RCRA FACILITY INVESTIGATION (RFI)
REPORT OF FINDINGS

PHASE II

For Person Generating Station Hazardous
Waste Storage Facility - Natural Pit Area
(NMT360010342)

August 28, 1990

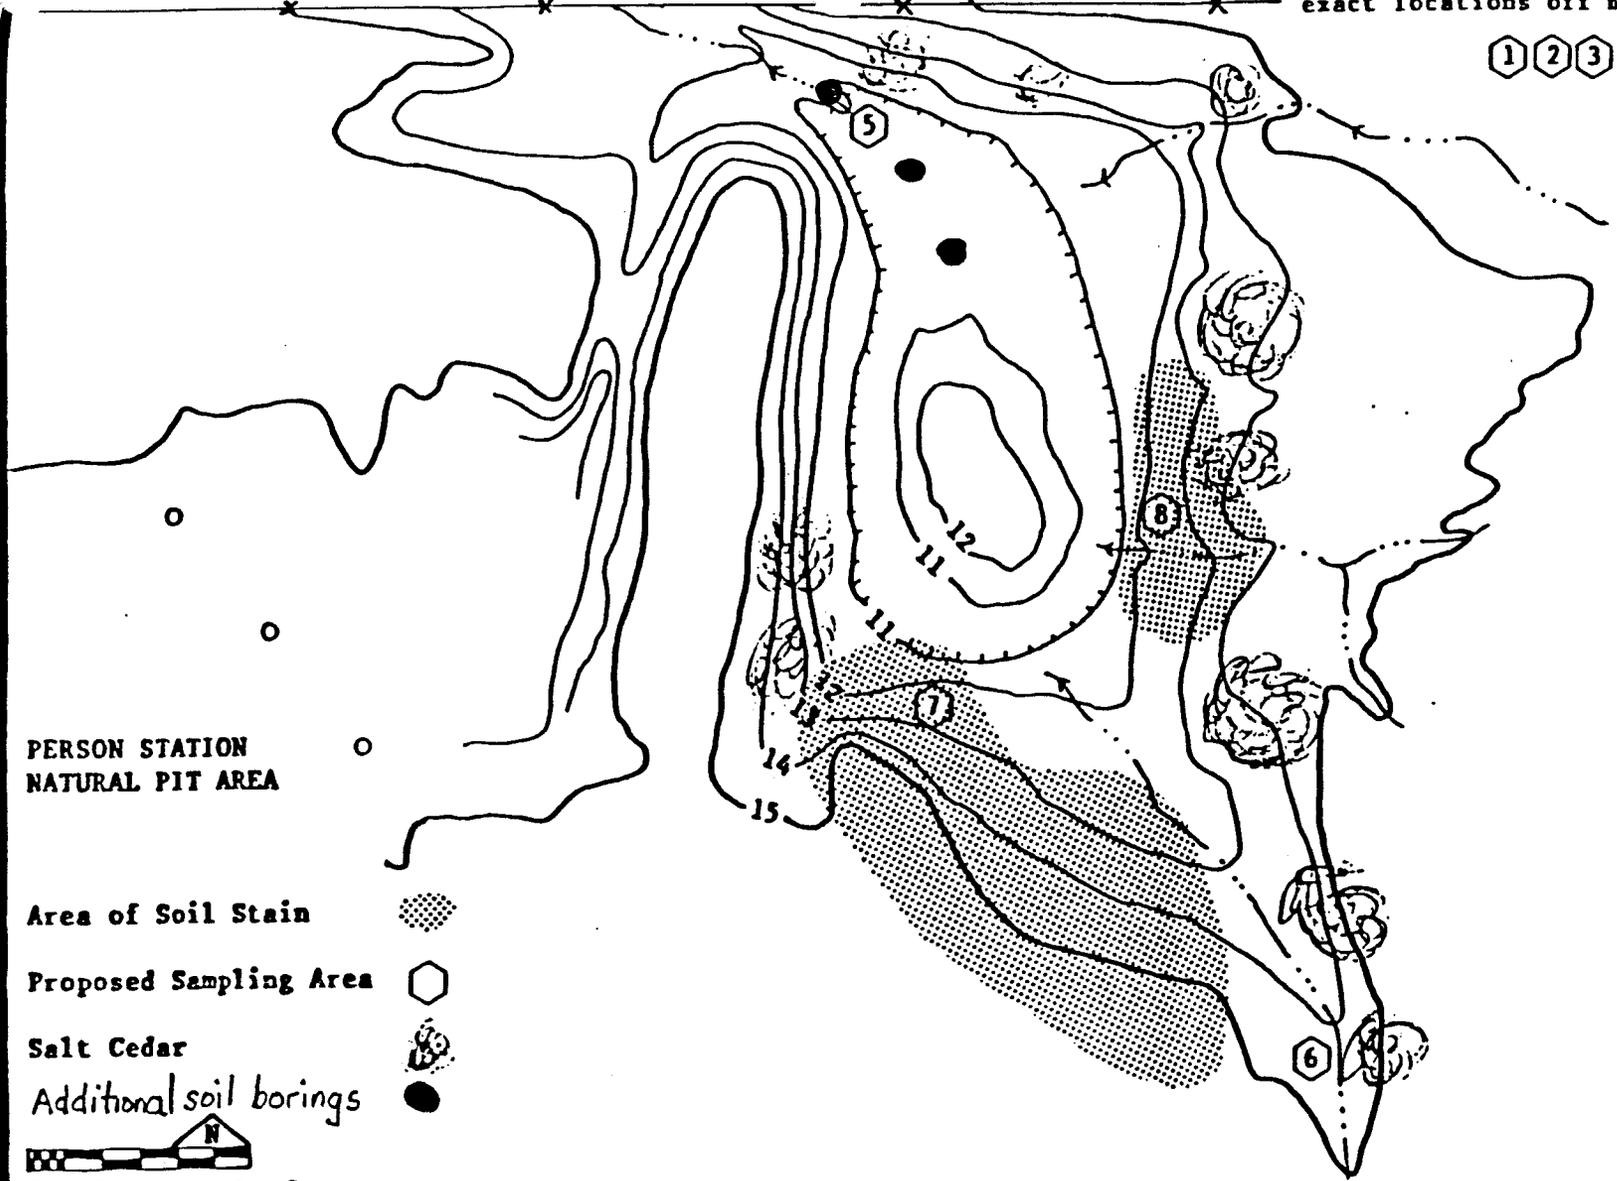
PSC shall take three soil borings with locations indicated on Figure 1. These borings shall be sampled at the following intervals: 0 - 1', 0 - 2', 4 - 5', and 9 - 10'. Each sampling interval shall be analyzed for lead, chromium, and arsenic. PSC may use the background soil samples from the 4 - 5' interval to compare to the active 9 - 10' soil sample interval. For these additional soil sampling requirements (Phase II), PSC shall comply with all requirements of the approved RFI Workplan (July 31, 1989).
